Re: Strata Energy, Inc. Ross In Situ Recovery Project
Source Materials License SUA-1601, Docket No. 040-09091
Additional Response to License Condition 10.13 Critical Verification Issue for
Mine Unit 1 Wellfield Data Package

On September 8, 2015, NRC staff issued a letter identifying the following critical issue for verification of the Ross Mine Unit 1 (MU1) Wellfield Data Package under License Condition 10.13:

Critical Verification Issue #2 –

Enclosure: PM12A and PM19A Location Map

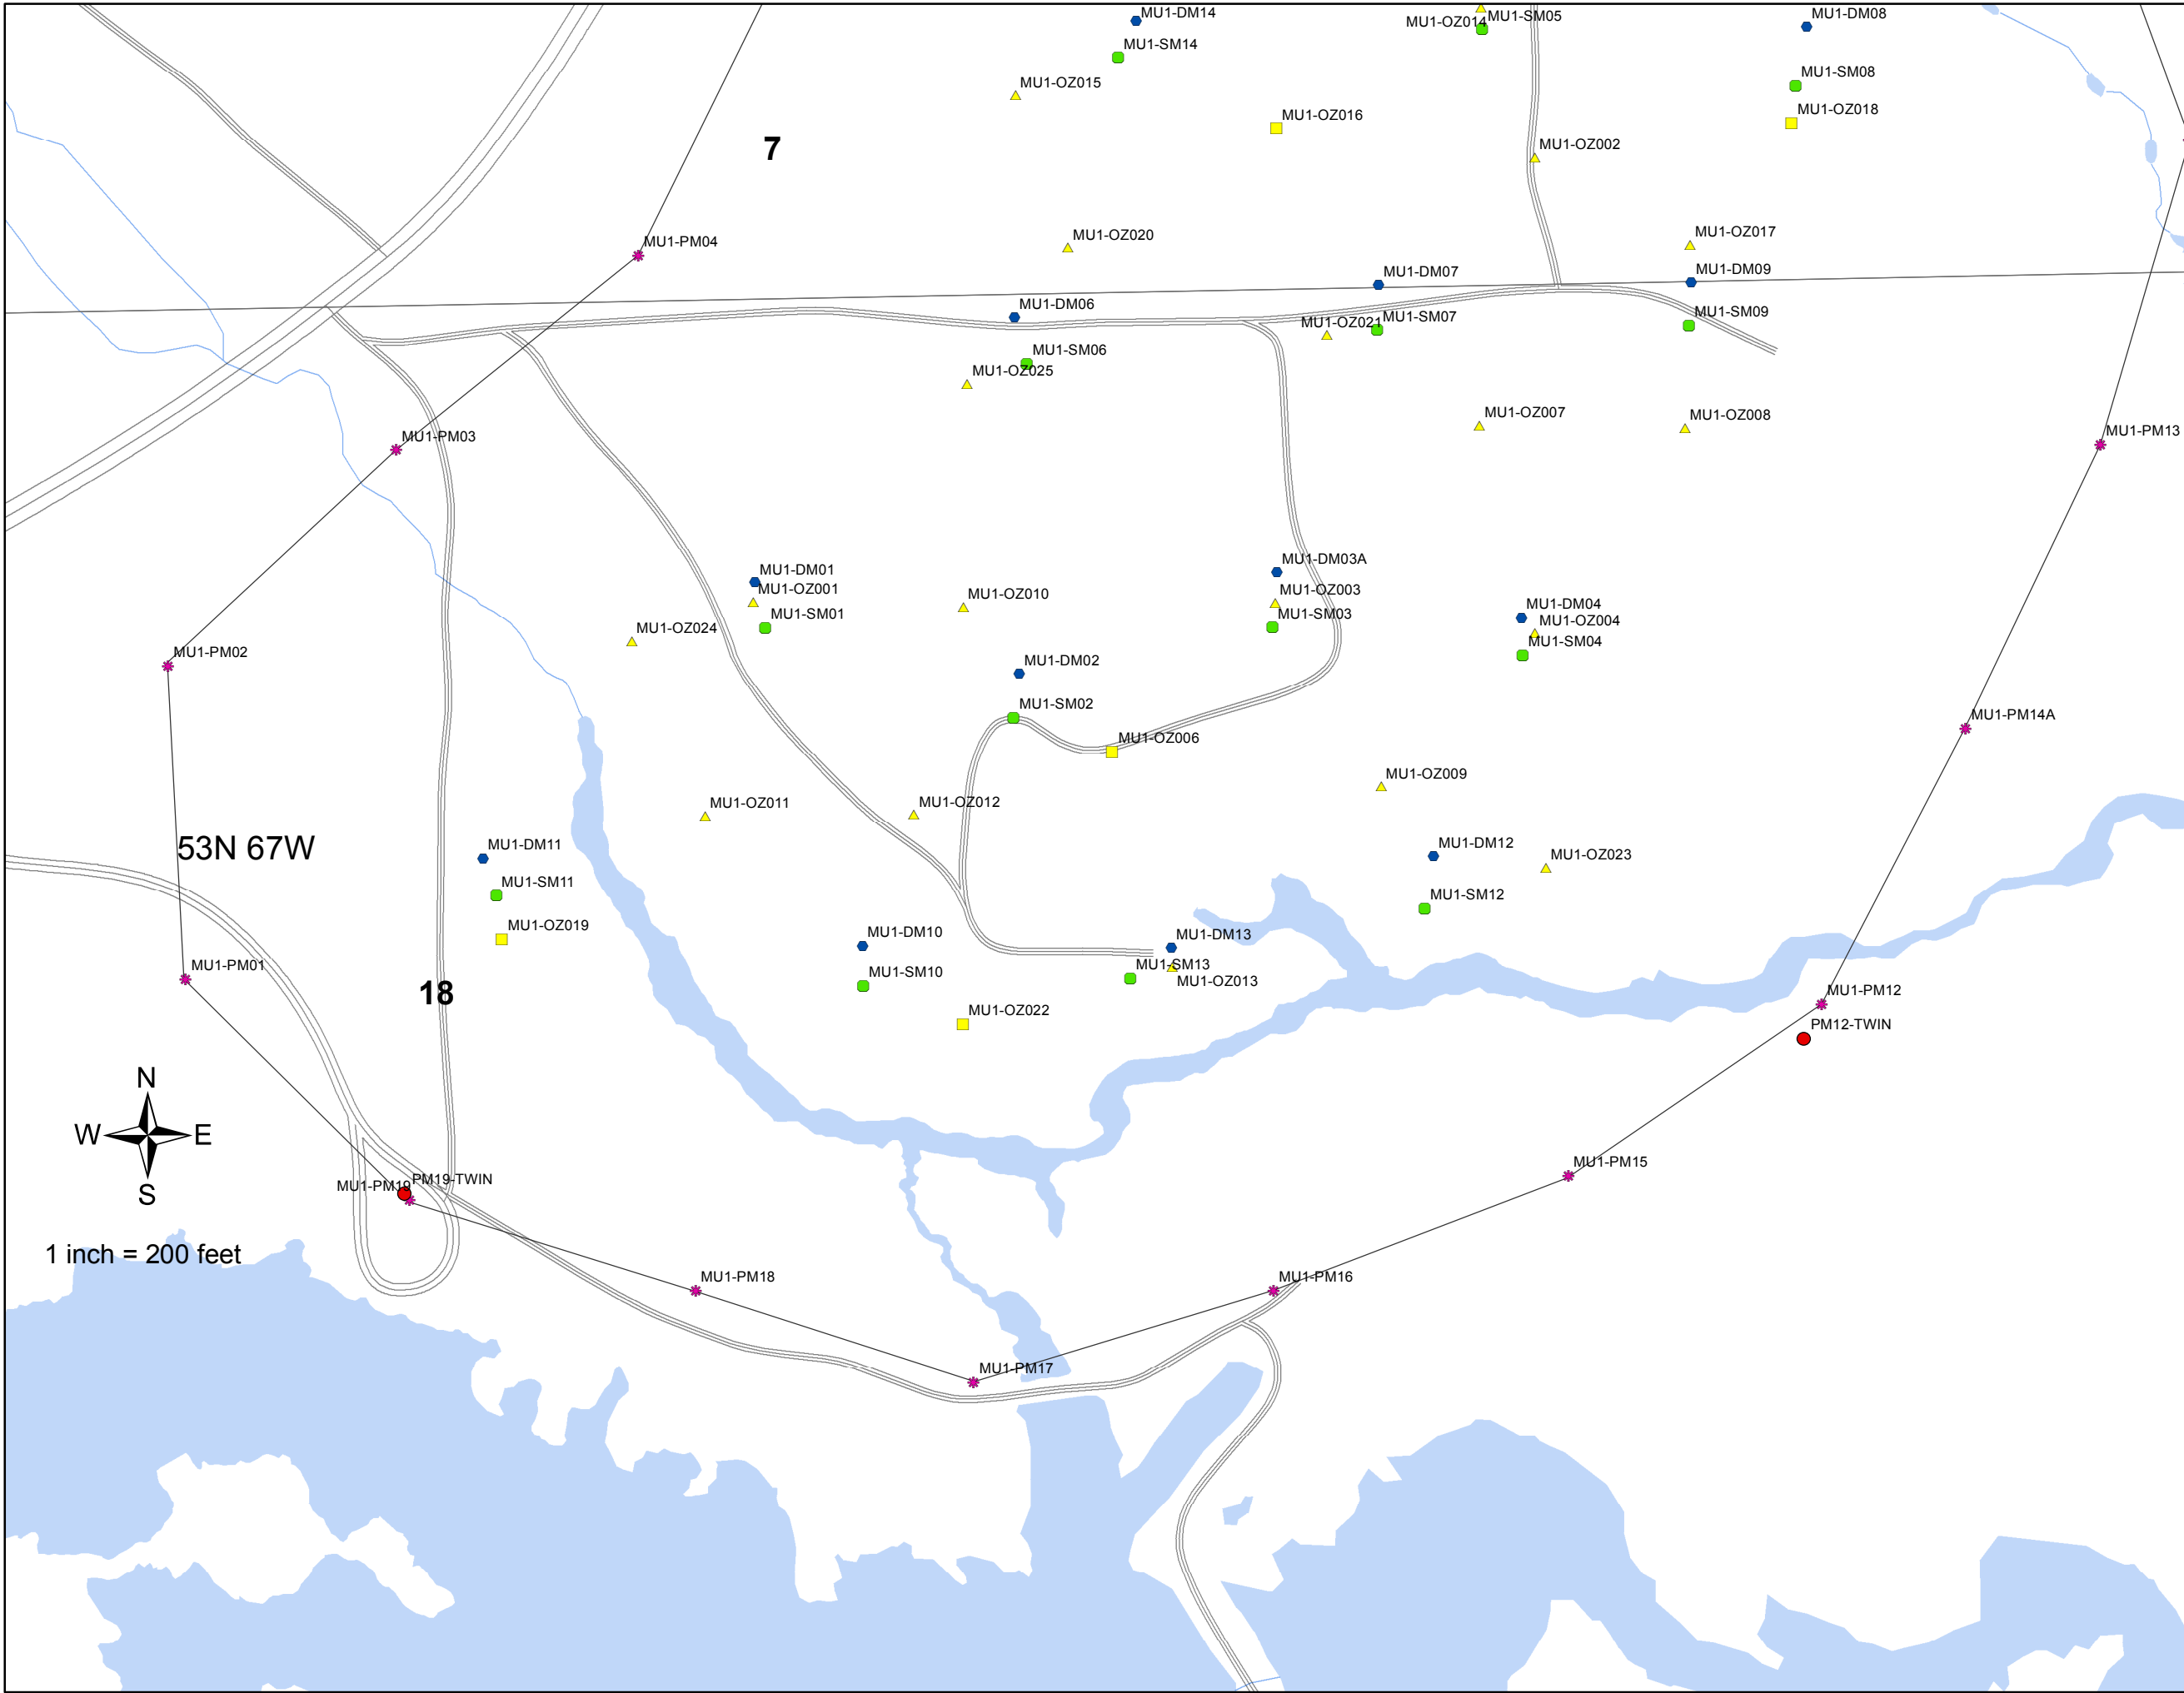
“License Condition 10.13 states: ‘The wellfield package will adequately define heterogeneities that may affect the chemical signature and ground-water flow paths within the ore zone as described in Sections 2.7.3.2.3, 3.1.1 and 5.7.8.1 of the approved license application.’ ... Strata has not addressed the issue of whether or not the perimeter wells along the southern boundary of the wellfield are in contact with the overlying aquifer. If correct, then Strata did not adequately define whether or not the wells’ ability to detect an excursion is diminished, whether or not the wells should be converted to partially penetrating wells, or whether or not an adequate thickness of the overlying confining unit exists in this area. Therefore, staff cannot verify that Strata met this license condition.”

By letter dated October 9, 2015, Strata Energy, Inc. (Strata) submitted the results of an additional aquifer test performed in the area and further evaluation. On October 20, 2015, Strata participated in a public meeting held by NRC to in part discuss Staff’s review of the October 9 submittal. As a result of this discussion, Strata agreed to install two additional perimeter monitor (PM) wells as “twins” to PM-12 and PM-19. These wells (with the preliminary identifiers of PM-12A and PM-19A) will be installed as close as

possible to the existing PM wells as shown on the enclosed figure. PM-12A is located approximately 50 feet from PM-12 due to trunk lines crossing the area and rough topography. It will be within 400 feet of the nearest mining well. PM-19A will be located very near PM-19.

The wells will be completed in the ore zone below the W Shale. Completion zones for these two wells will be approximately:

PM12A: 315 ft. to 420 ft.

PM19A: 370 ft. to 490 ft.

The wells will be completed in the ore zone below the W Shale. Once the wells are installed, mechanical integrity tested, and developed, they will be sampled for the parameters listed in Table 5.7-2 of the approved license application, as revised by the May 27, 2015 submittal (ML15149A023). The results for excursion parameters will be compared with the baseline results for PM-12, PM-19 and the remaining PM wells and, from this comparison, appropriate Upper Control Limits (UCLs) will be determined.
